Submission on Proposed Plan Change 7 – Rotokauri North Private Plan Change

Proposed Plan Change 7 Submission

Figure 15 -7a

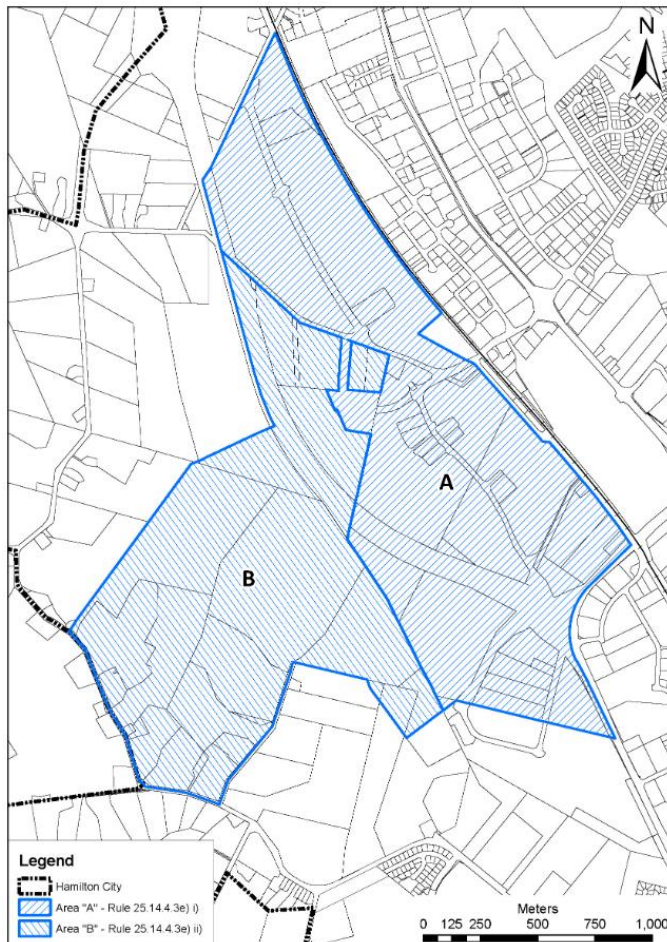
The proposed plan change is inconsistent with structure plan component *“3.6.3.2 Roding”* in its entirety. The proposed area is within the stage 2 area, outside of Areas A and B (see Figure 15-7a). The Rotokauri Structure Plan indicates that the release of land beyond stage 1A (such as the PPC): *“will be contingent upon the availability of network capacity which may arise as a result of traffic generation”* and 3.6.2.3 d and e) provide that:

Proposals for the development of land in ‘Area B’ on Figure 15-7a will require careful scrutiny to ensure that adequate network capacity exists to support the development, or will be provided as part of the development and they will not compromise the development of land in ‘Area A’ on Figure 15-7a. Development will require:

e) The development of land outside Areas 'A' and 'B' (Figure 15-7a) will need to coincide with the northwards extension of Rotokauri Minor Arterial Road to connect with Te Kowhai Road at the City Boundary.

The PPC is clearly contrary to these provisions, and the developer is trying to dodge the full cost of developing ahead of the planned sequencing by exempting itself from these Rotokauri Structure Plan provisions. The PPC does not provide adequate transport network capacity outside of the PPC area to support the proposed development. The proposal does not achieve a sustainable expansion of the city and does not represent coherent and integrated development, because the transportation effects beyond the Rotokauri North boundaries have not been resolved.

- Either decline the private plan change; or
- Decline proposed inclusion of section 3.6 d (exemption of PPC area from Rotokauri Structure Plan), but approve the development subject to requiring the developer to adhere to all existing Rotokauri structure Plan provisions, including:
 - a) requiring they construct the Rotokauri Minor Arterial Road;
 - b) provide an ITA that adequately assesses impacts on the wider transport network and have that ITA peer reviewed.
 - c) cater for the demand generated within the wider transport network;

- d) requiring the developer to fund all necessary road network upgrades and additions.
- e) provide a full economic assessment of the financial impact on the remainder of the Rotokauri Structure plan area and including the likely cost of the required roading upgrades.
